SERVICE BULLETIN

Service Bulletin No. 627E
 Supersedes Service Bulletin No. 627D
 Engineering Aspects are
 FAA Approved

SUBJECT: Exhaust System Inspection

MODELS AFFECTED: Lycoming Engine Model TIO-540-AJ1A

Figure 1
Exhaust System (#1, #3, #5 Cylinder - Right Side of Engine)

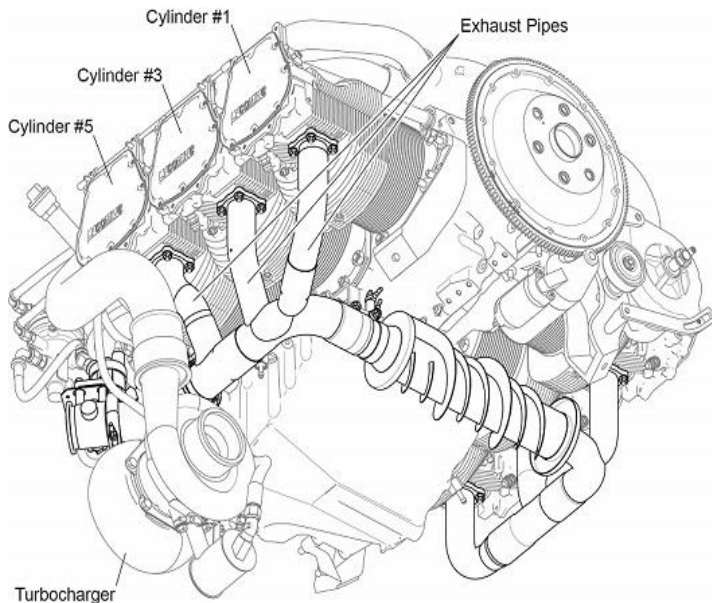
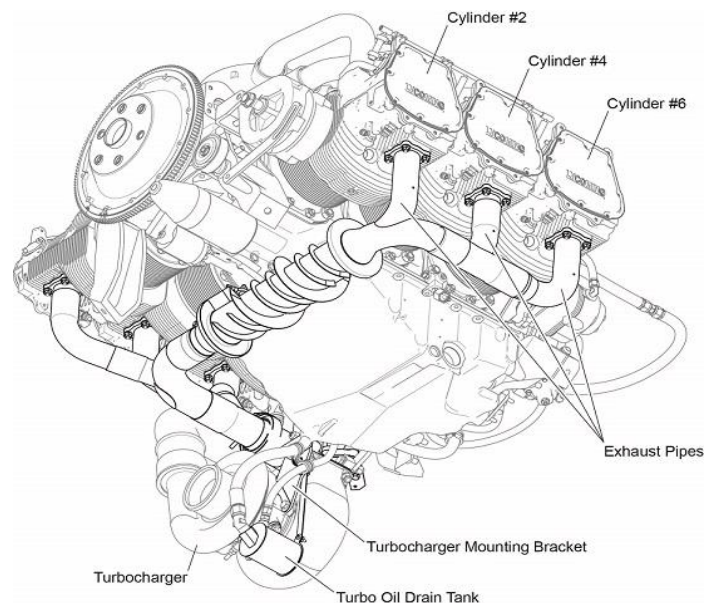
- A. To access the exhaust system (Figures 1 and 2), remove any airframe components as necessary per the airframe manufacturer's instructions.

C. Examine the weld joints of the exhaust pipes for all cylinders (Figures 1 and 2). Closely examine the saddle reinforced weld joints (Figures 11 and 12), especially at Cylinder 3. If any cracks or damage is found, document the issue then replace with serviceable parts.

- E. Complete a visual inspection on the entire exhaust system (Figures 1 and 2). If any sign of leaks, distortion, or damage is found, document the issue then replace with serviceable parts.
- 2. Flange Nut Torque Check
 - A. Since loose flange nuts can be an indication of a potential exhaust leak, complete a torque check on exhaust system flange nuts for all six cylinders.
 - B. If a flange, stud, flange nut, or pipe is distorted or visibly damaged, document the issue then replace with serviceable parts. If it is just a leaky gasket, determine root cause, and replace the gasket and hardware with new parts.
 - C. Check the fractional amount each flange nut turns to achieve the required 96 in.-lb (11 Nm) torque. If any flange nuts are loose enough to allow movement of the washer, contact Lycoming Engines' Product Support.

Figure 4
TIO-540-AJ1A Turbocharged Exhaust System

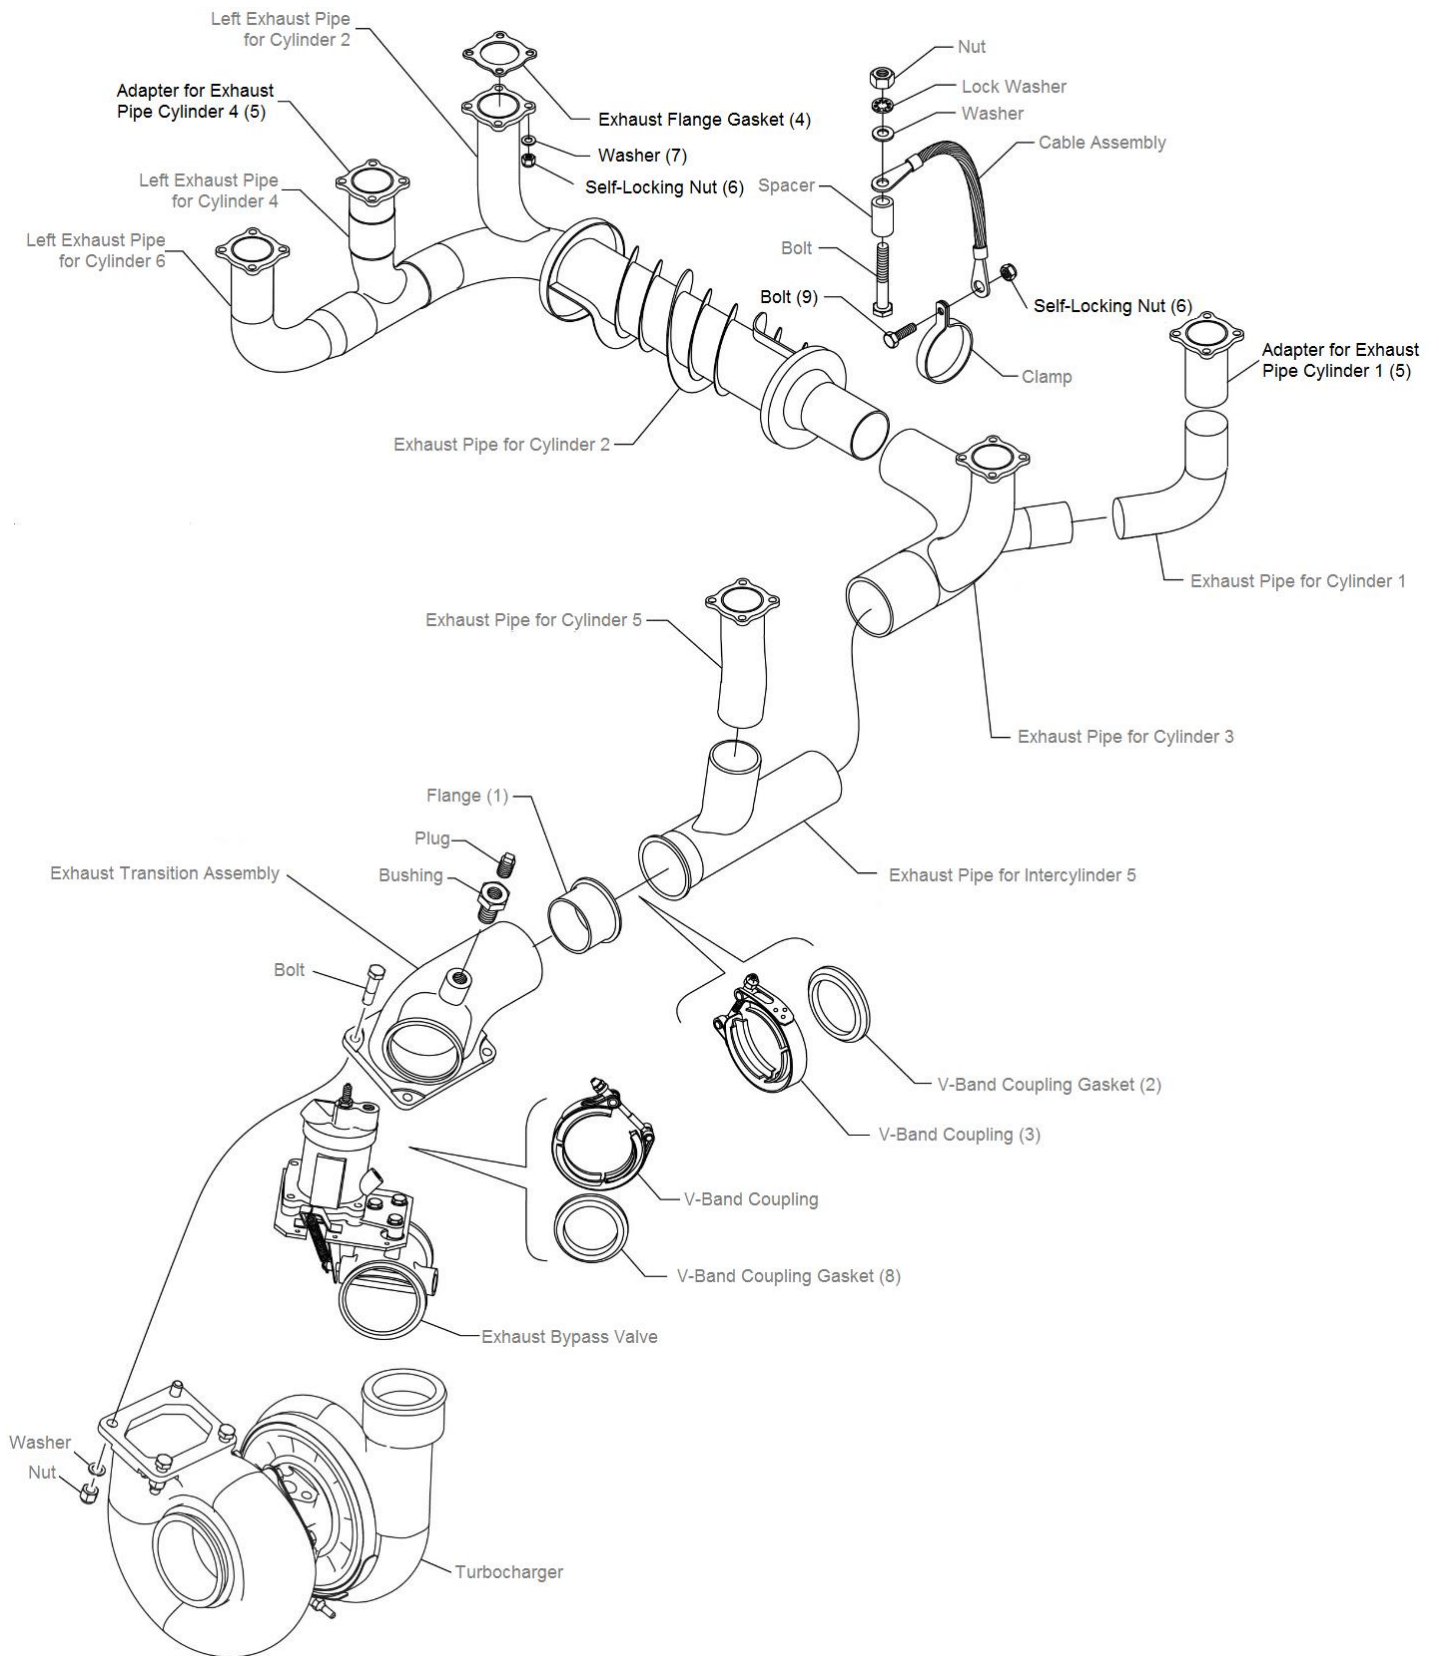
- C. Remove and discard No. 5 exhaust pipe V band coupling and coupling gasket from the exhaust transition assembly flange (Figure 4).
- D. Remove and discard the bolt and self-locking nut from the No. 2 exhaust pipe support clamp end of the cable assembly. Save the clamp for reassembly (Figure 4).

- ⚠ CAUTION:** AS A SAFETY PRECAUTION, USE THREE PEOPLE TO COMPLETE THE NEXT STEPS TO PREVENT INJURY AND PARTS FROM FALLING.
- E. While one person removes the self-locking nuts and washers from the vertical portion of the exhaust pipes on the engine (Figures 1 and 2), two people lower and remove the exhaust pipes as one piece and separate the pipes between No. 2 and No. 3 slip joint (Figure 4)

E. Install the new flange into the exhaust transition assembly (Figure 4).

H. Install two new exhaust flange gaskets on each cylinder exhaust port (Figure 4). (Refer to the latest revision of Service Instruction SI-1204 for exhaust flange gasket information.)

- T. Complete final torques to ensure all fasteners are torqued.
- U. Torque the 4 nuts that attach each pipe to the cylinders (Figure 4) to 96 in.-lb. (11 Nm) -on all cylinders.

- W. Install the exhaust system end of the cable assembly (Figure 4) with a new bolt and new self-locking nut. Torque the bolt and nut to 96 in.-lb. (10.9 Nm).

Figure 5
Turbocharger

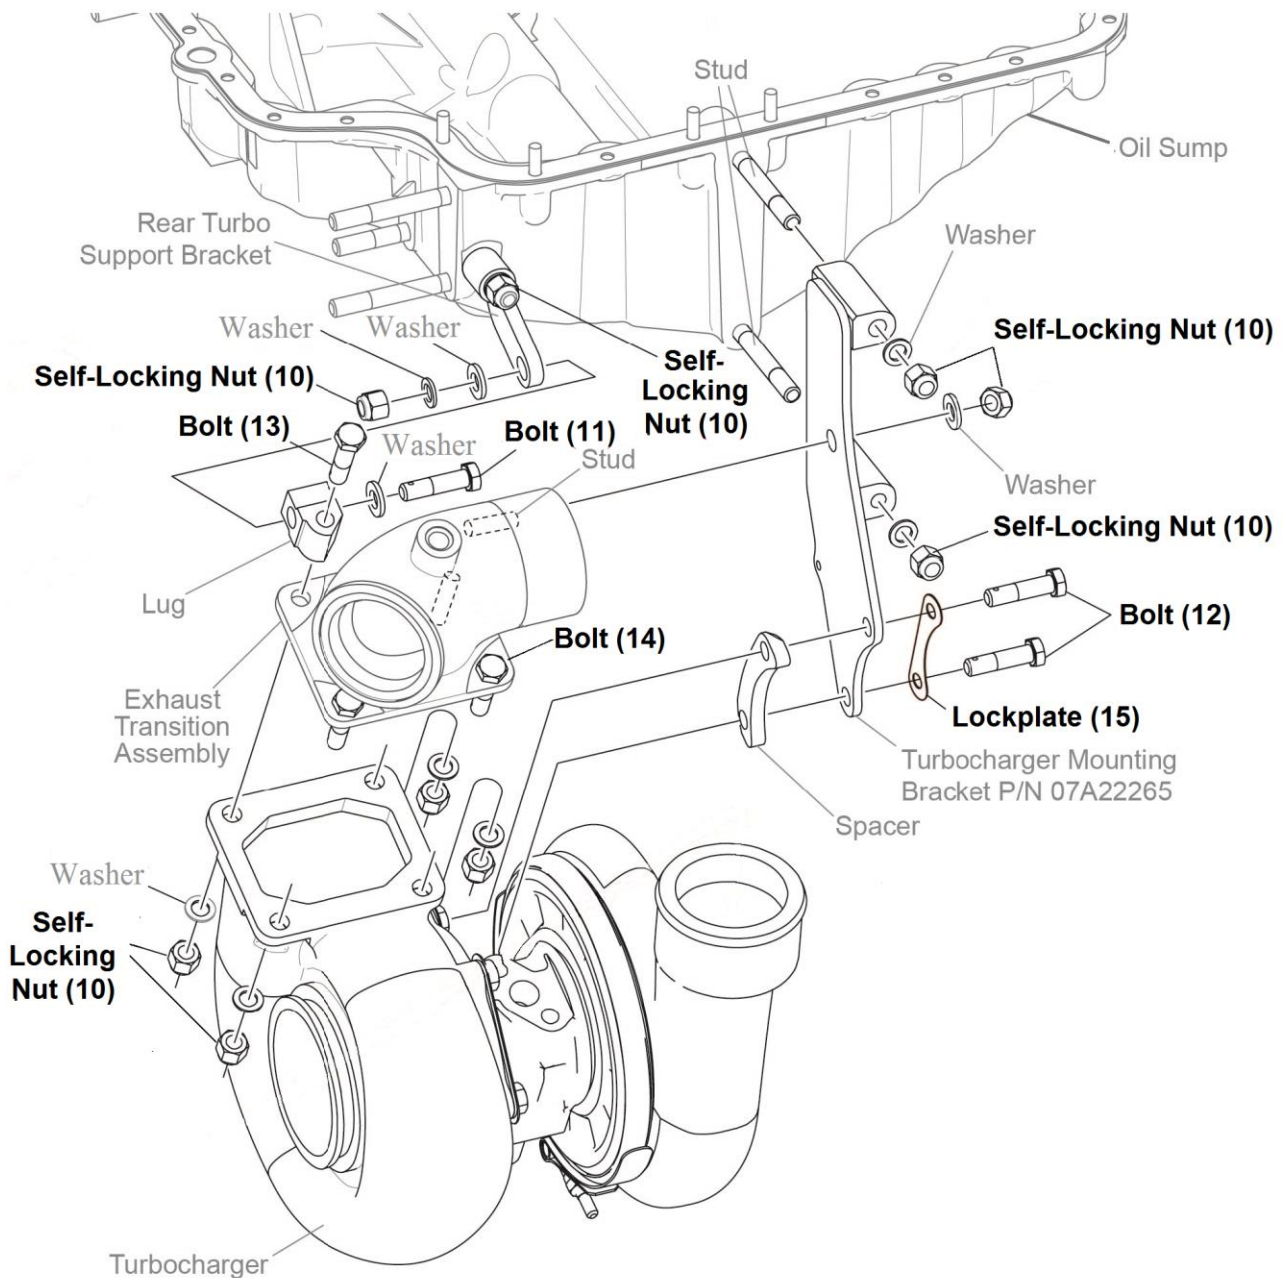
NOTICE: Optional, the following steps, (1 thru 5 and i thru ix) outline the loosening and tightening of the turbocharger and associated mounting points to aid in new exhaust system alignment if required. All exhaust system components can be adjusted if needed to ensure proper alignment as the new exhaust system kit is installed, (Figure 5) Do not force or bend connecting parts, loosen in the order described following steps 1 thru 5.

NOTICE: Use the following steps (i thru ix) as required for reassembly, if components are loosened, or removed (Figure 5).

- iv) Loosely install the three washers and new self-locking nuts that attach the turbocharger brackets to the oil sump.
- v) Loosely attach the two new bolts through a new lock plate, the turbocharger mounting bracket, and spacer into the turbocharger.
- vi) Adjust brackets, exhaust transition assembly and turbocharger to gain proper exhaust system alignment, and tighten bolts and nuts sufficiently to maintain alignment of the exhaust system. Do not over tighten. Torque hardware per the following steps.
- vii) Torque the self-locking nuts on the 2 turbocharger to oil sump mounting brackets to 30 ft.-lbs. (40.7Nm)
- viii) Torque the self-locking nuts that attach the exhaust transition assembly (Figure 5) to the turbocharger to 30 ft.-lbs. (40.7Nm)
- ix) Torque the nut that attaches the exhaust transition assembly to the turbocharger mounting bracket (Figure 5) to 30 ft.-lbs. (40.7Nm)

Figure 6
P/N Only on Exhaust Pipe 2

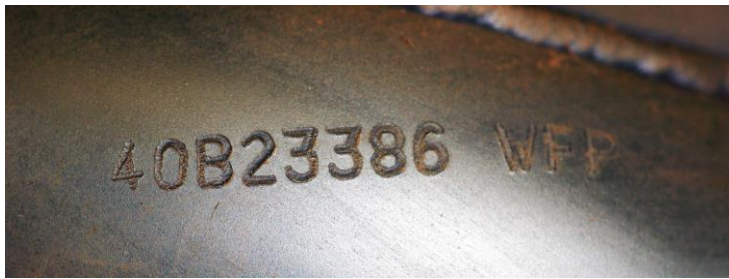
- Examine Exhaust Pipe 2, identify any stamped markings.

- Only the part number (P/N) (Figure 6). All pipes will be stamped with at least the P/N.
- The P/N and the Release ID# (Figure 7)
- The P/N, Release ID#, and a date code (Figure 8)

Figure 13
Signs of Exhaust Leak

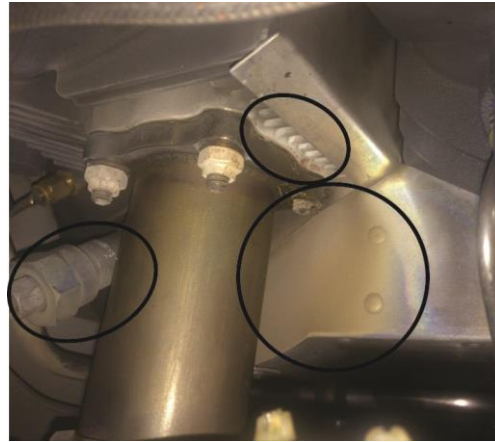
D. Examine all cylinder exhaust flanges (Figure 13) for damage, distortion, or signs of exhaust gas leaking past the gasket, especially at Cylinder 2. Indications of a flange gasket leak are burnt paint around the exhaust flange bosses or powdery white to light brown or black residue near the leaks, on the spark plug, and the baffle. If the flange or pipe is distorted or damaged, document the issue then replace with serviceable parts.
